HIGHGROVE-1
COMPLIANCE PACKAGE 'A1'

Greenpark.
Project name: RUSSELL GARDENS PH2
Municipality: WATERDOWN, ON.
Date: APRIL 2017
Scale: 3/16" = 1'-0"
Drawing no. 16036-HIGHGROVE-1

HIGHGROVE 1
Project no. 16036
Drawing no. A1a

SECOND FLOOR PLAN - ELEV. 2

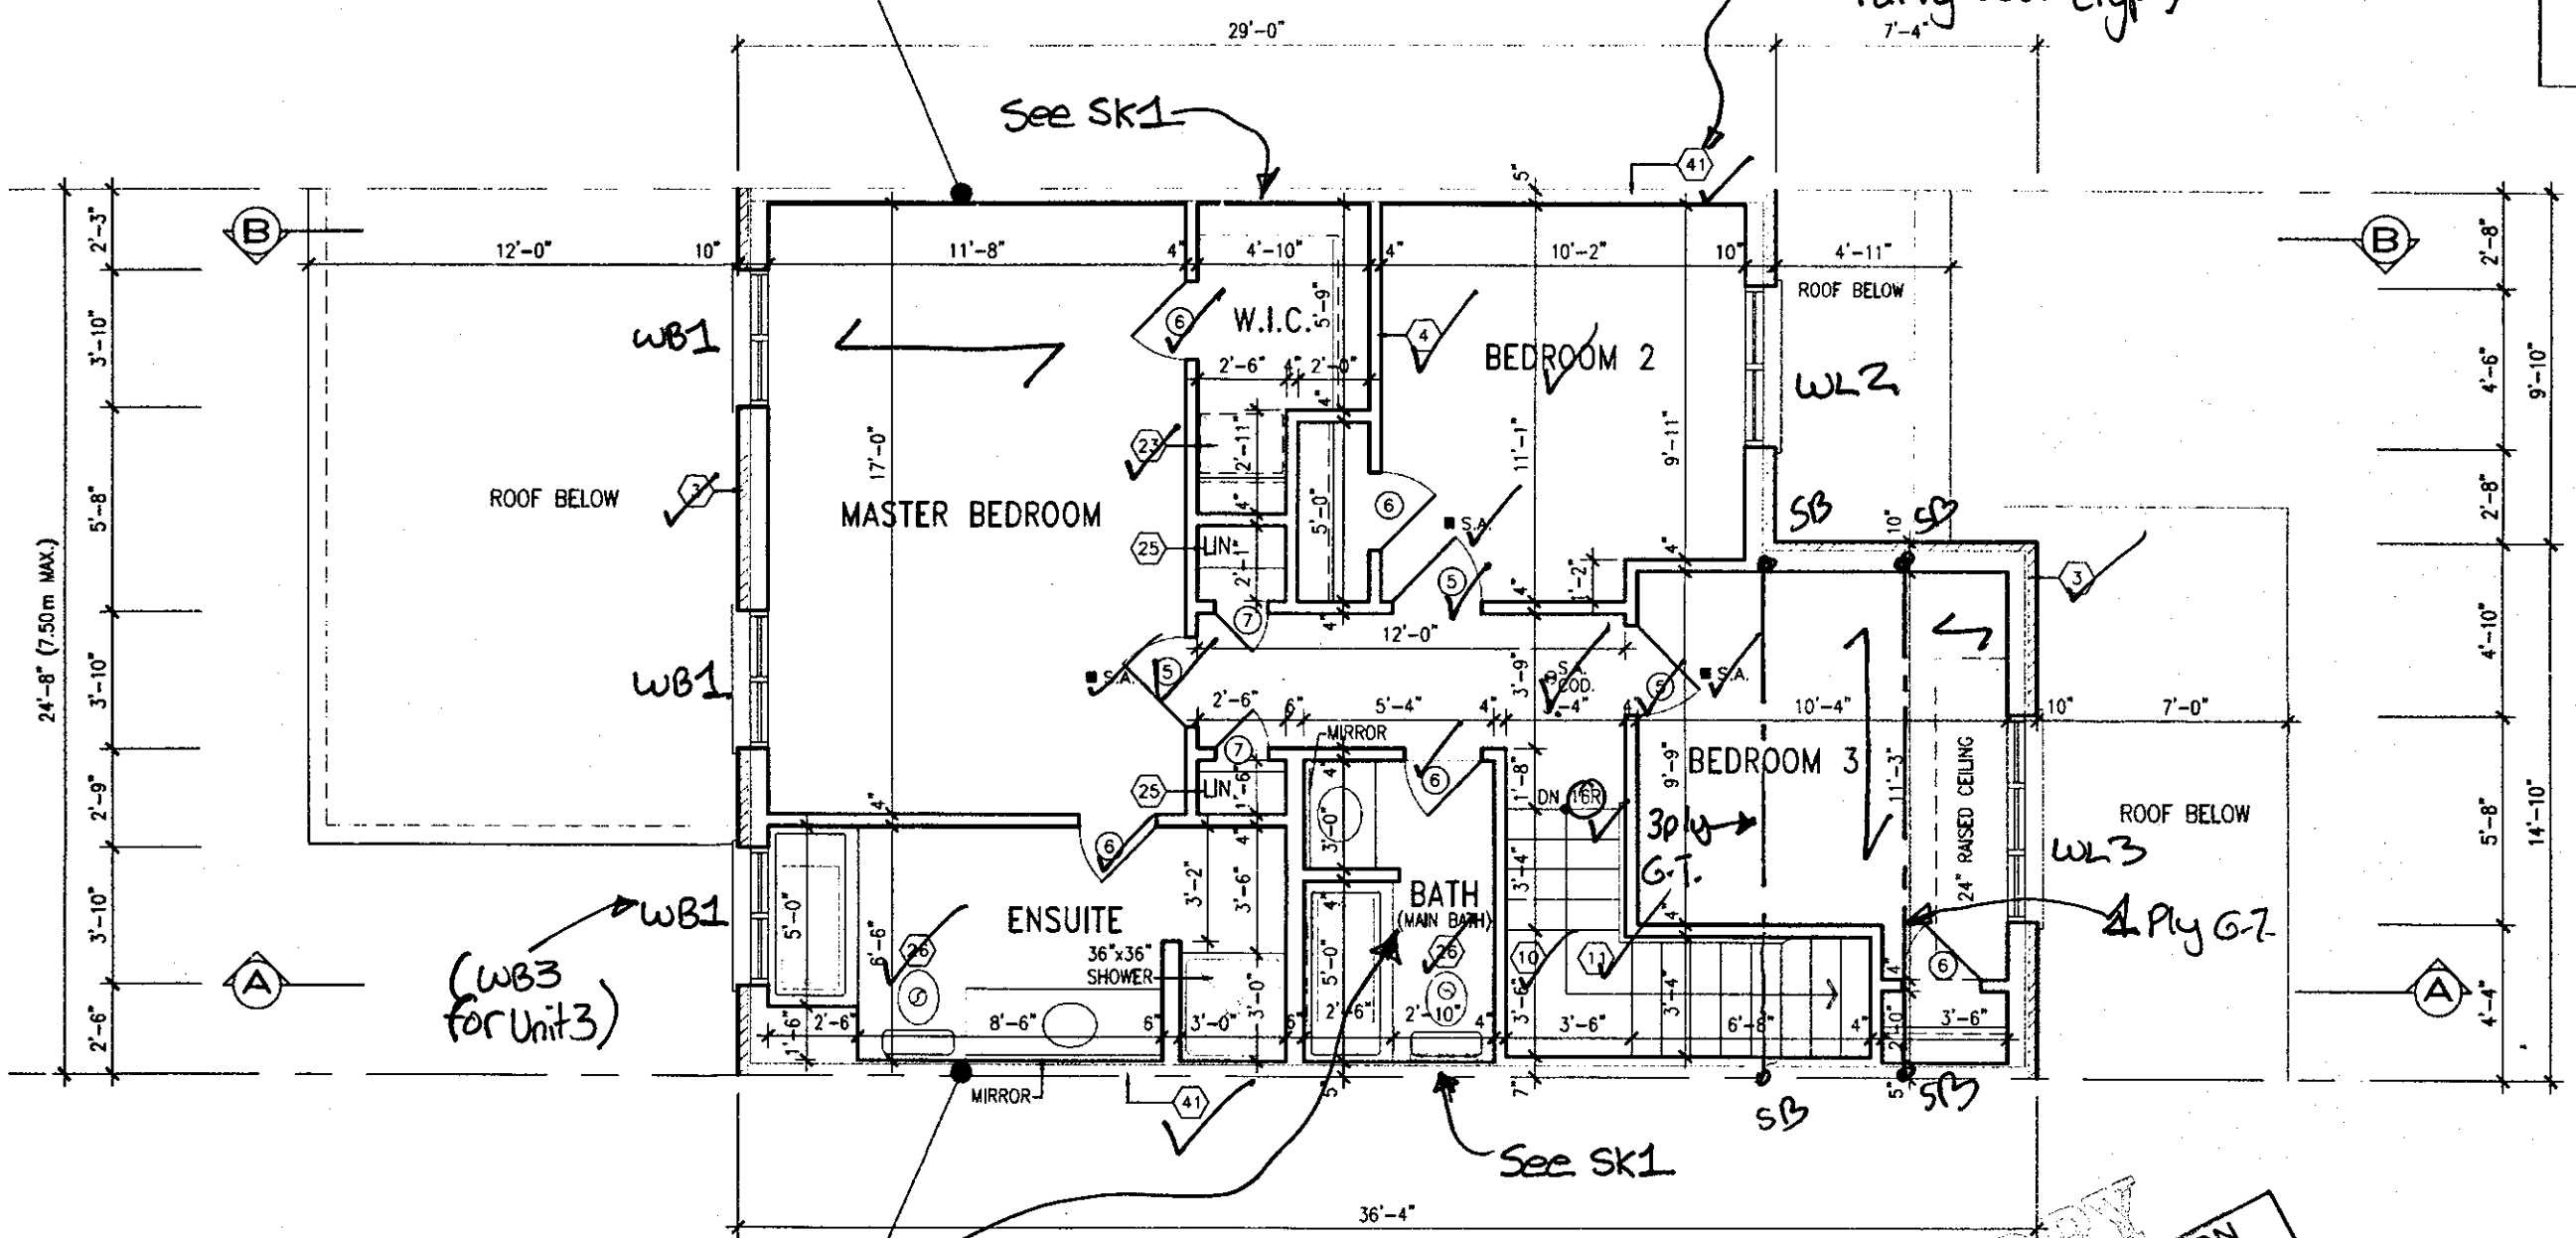
See Trusses for Unit 3 for changes

Required at stairs for unit 5, Unit 3

PART. SIDE ELEVATION
WOB CONDITION

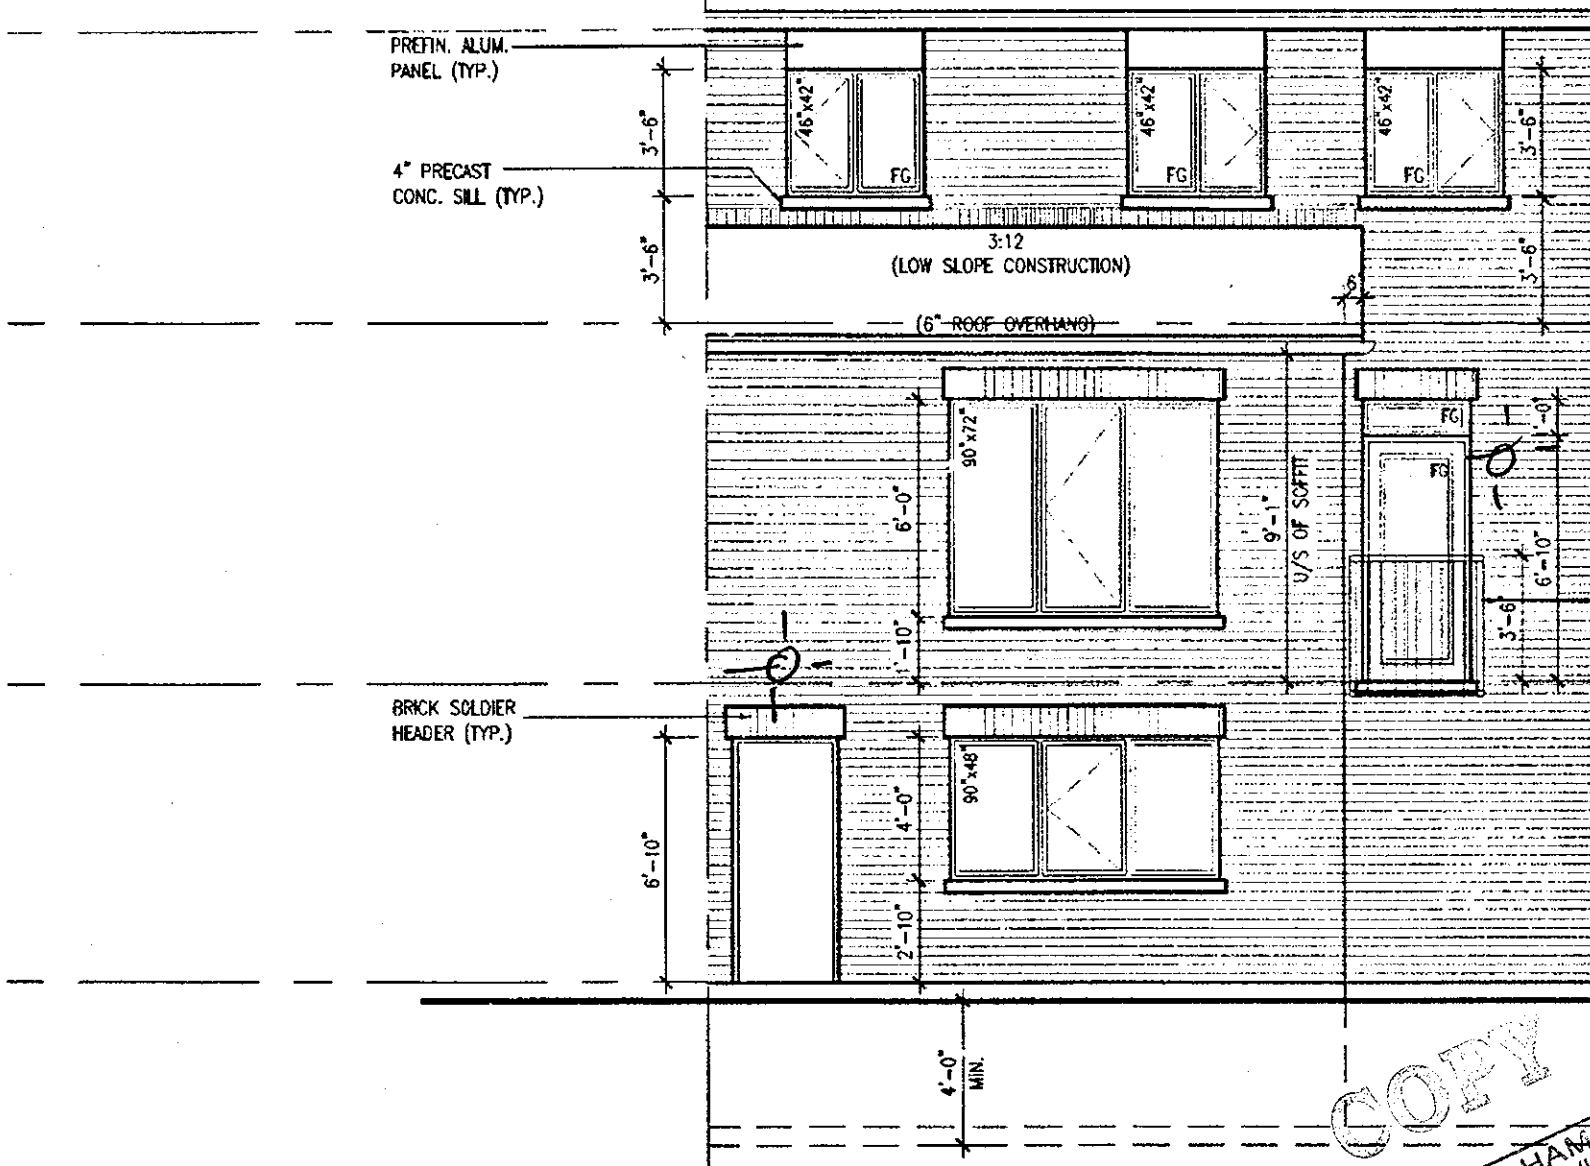
WALL AREA 206.04 SQ. FT.
LIMITING DISTANCE 2.1m 2.7 M (25%)
OPENING ALLOWED 30.4-51.61 SQ. FT.
OPENING PROVIDED 28.5 SQ. FT.

80-OK
